<h1>FLARM FIRMWARE RELEASE NOTES</h1>	Date: 2022-06-06 Version: 1.1 Page: 1 of 46
FLARM Technology AG Industriestrasse 49 CH-6300 Zug		Document Number: <b>FTD-037</b>

# FLARM Firmware Release Notes

*Published 9 June 2026*

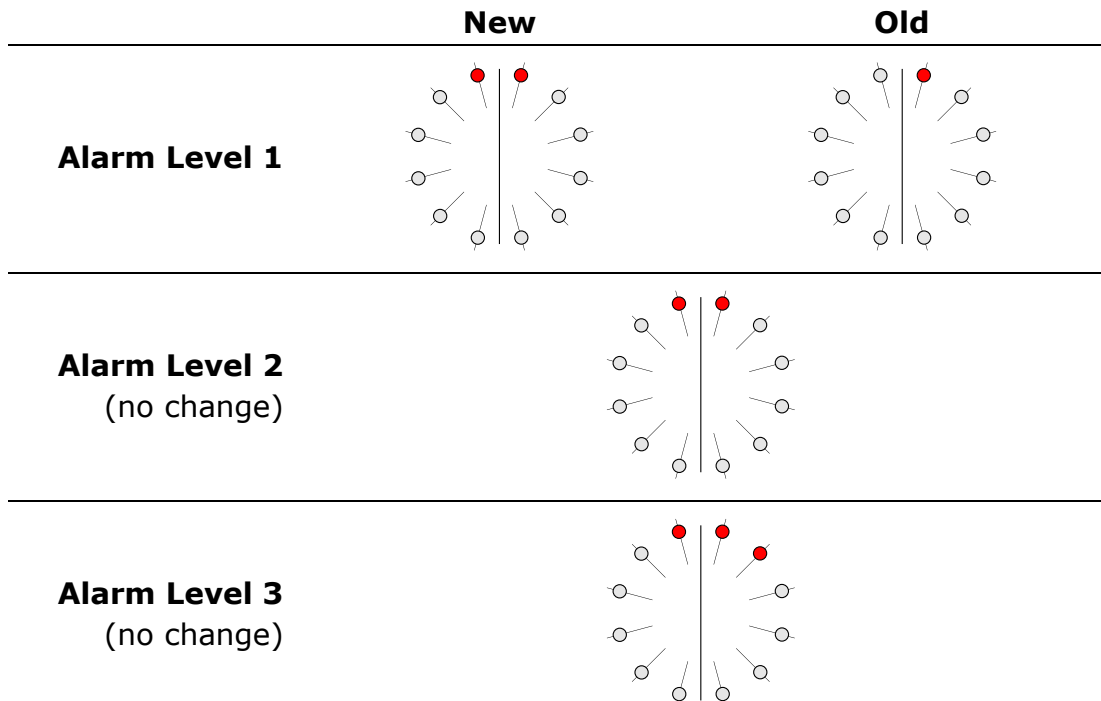
**Note:** On Classic FLARM, the firmware version is indicated as shown in the graphic below:

**Note:** Head-on ( $\pm 15^\circ$ ) traffic and collision warnings on Classic FLARM F6–F9 are indicated as shown in the graphic below (the traffic in this example comes from  $+5^\circ$  relative bearing).
